## MEMORANDUM

**TO:** ARCHITECTURAL REVIEW BOARD  
**FROM:** Kate Schwartz, Historic Resources Planner  
**DATE:** May 9, 2016  
**SUBJECT:** Certificate of Appropriateness for exterior alterations at 201-203 William Street

A.1  
SHEET 1 OF 3

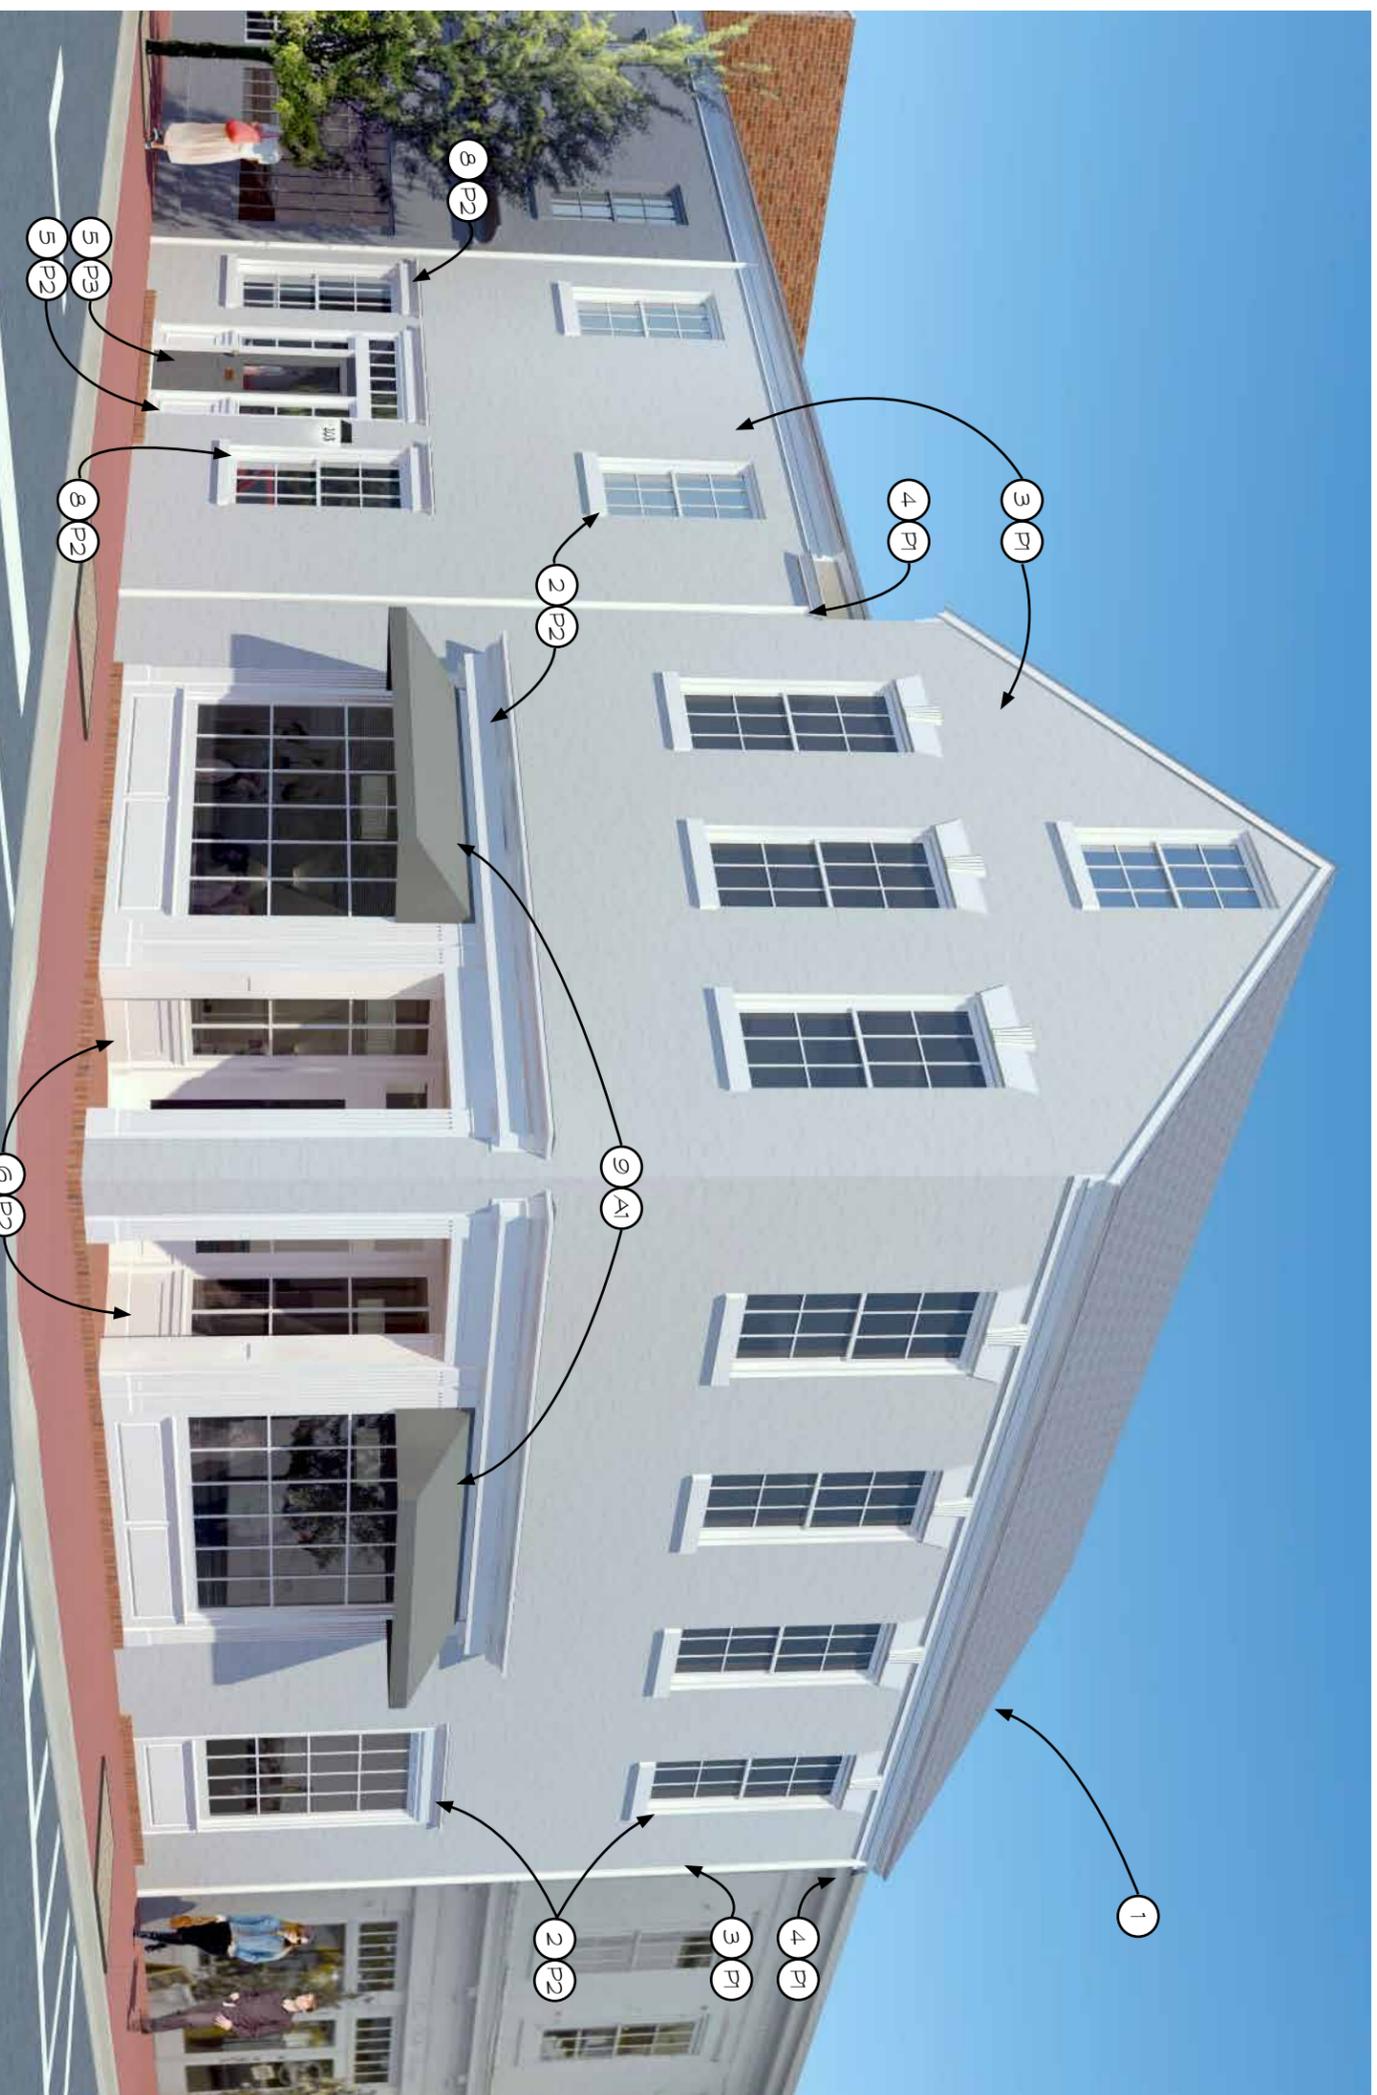
- The display window centered in the 203 William Street elevation will be replaced with a half-glazed, two-panel wood entry door with sidelights and transom to fit the existing opening in the brick. The existing display window is not a contributing feature of the building, and a door was historically placed in approximately this location. Staff finds that this alteration reflects

- The aluminum corner entry paired doors will be replaced with a single glazed wood door, sidelights, and transom. It is unknown if the existing doors are original to the c.1946-1950 corner entry configuration. The proposed design maintains the existing entry and is compatible with the character, materials, and design of the structure. The alteration is compatible with the character of the Historic District.

- New fabric awnings with loose six-inch deep valances and open corners will be installed between the pilasters and beneath the cornice, over the display windows on the 201 William Street building. Awnings were previously installed over these display windows, as shown in the c.1950 photograph. The placement, design, material, and color of the proposed awnings are compatible with the historic character of the structure and the District.

- If repair of the existing slate roof is not feasible, the roof will be replaced with synthetic slate shingles. In the National Park Service’s *Preservation Brief 29: The Repair, Replacement, and Maintenance of Historic Slate Roofs*, the author states, “If 20% or more of the slates on a roof or roof slope are broken, cracked, missing, or sliding out of position, it is usually less expensive to replace the roof than to execute individual repairs. This is especially true of older roofs nearing the end of their serviceable lives.” It is likely that the current roof dates to the original construction of the buildings and has been in place for 191 to 194 years. Synthetic slates have been used successfully within the district; however, staff recommends continuing this request to allow the applicant to provide additional information on the proposed material.

Approval of the Certificate of Appropriateness for all requested items except replacement of the roof. Additional details on the proposed synthetic slate are needed for consideration.
